RE: Mail Control Number: 578146
Radioactive Materials License Application for:
Spring Hill Cardiology, PLLC
428 Division Street, Suite 1A
Charleston, WV 25309-1469

9.1 Facility Diagram

Overview Diagram:

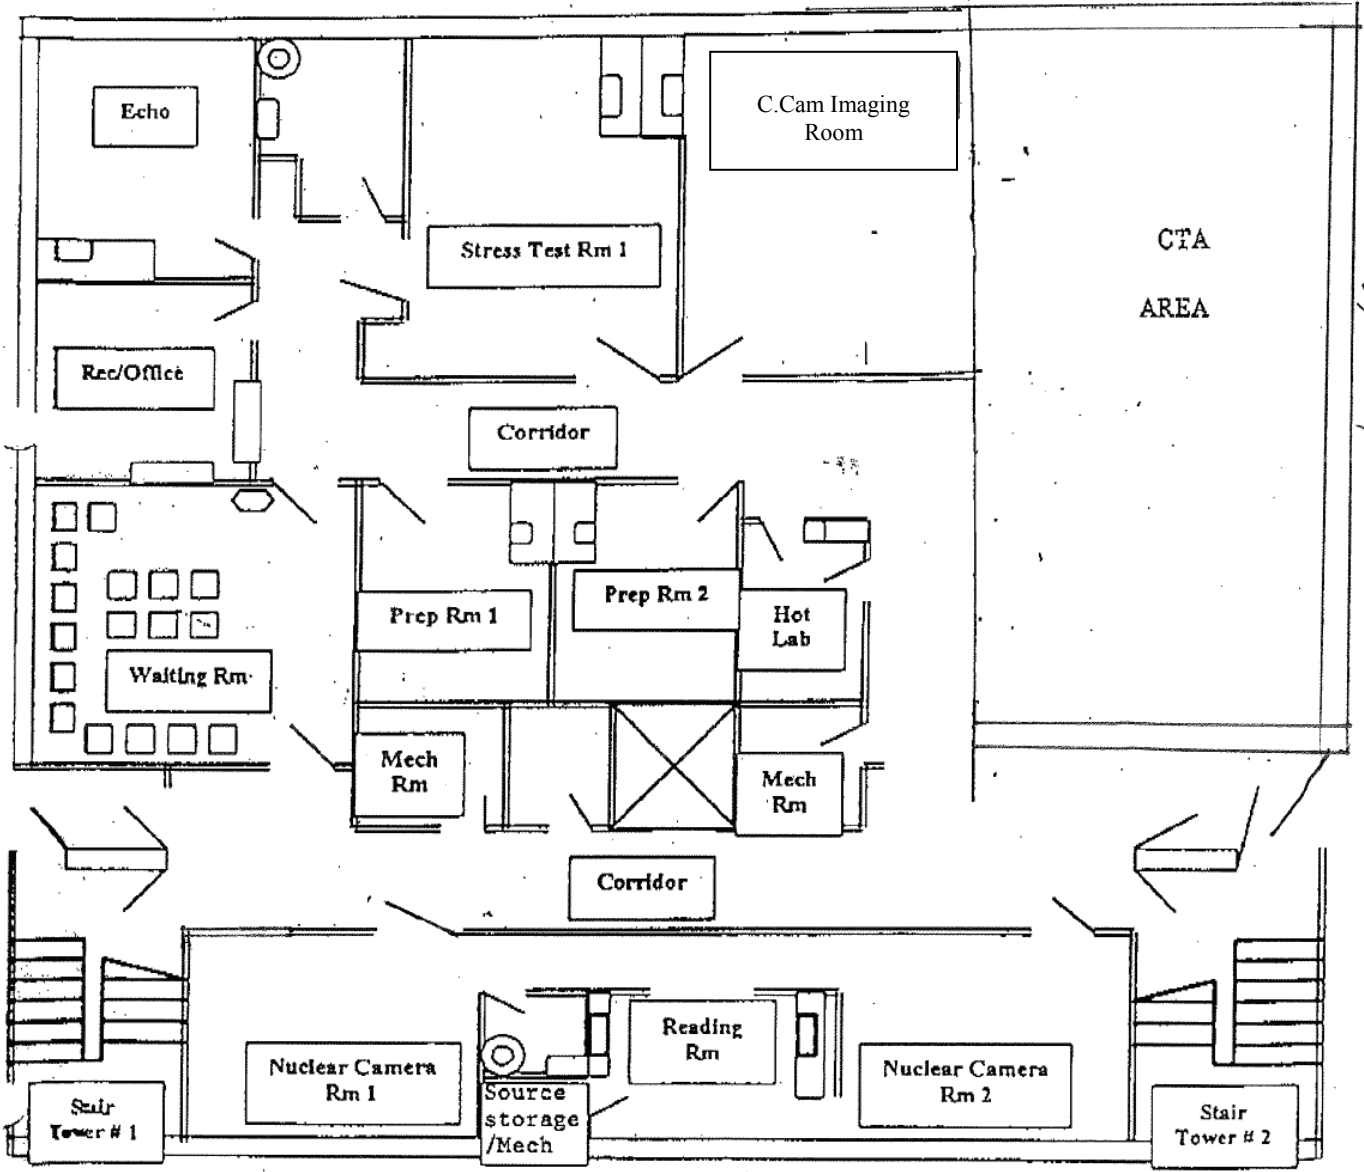
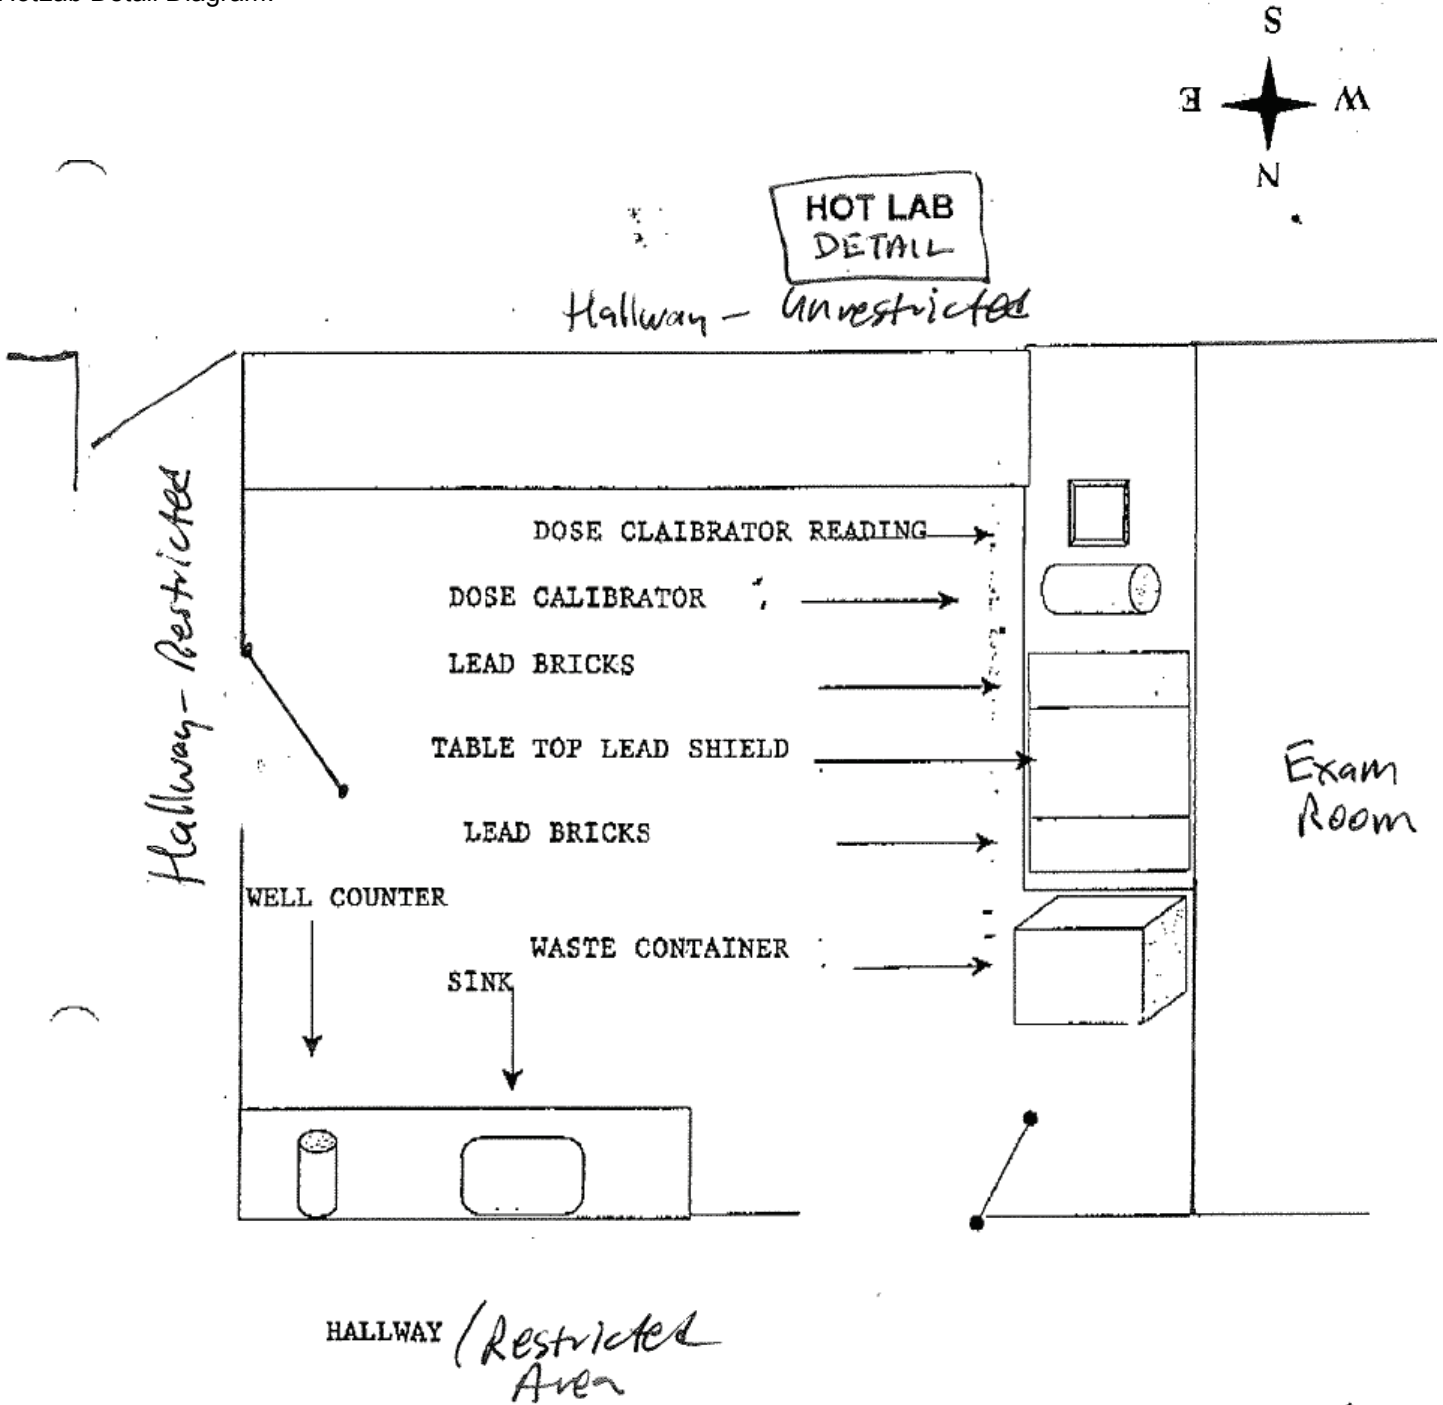
We wish to make a change to the facility layout of our radioactive materials application. We would like to install a Siemens C.Cam dedicated nuclear cardiology gamma camera in what is currently known as Stress Room 2 which will subsequently be known as the C.Cam Imaging Room as shown on the attached diagram. For your review, please find the attached revised Item 9.1. Please replace the previously submitted Item 9.1 with this revised version. There are no other changes that affect our application.
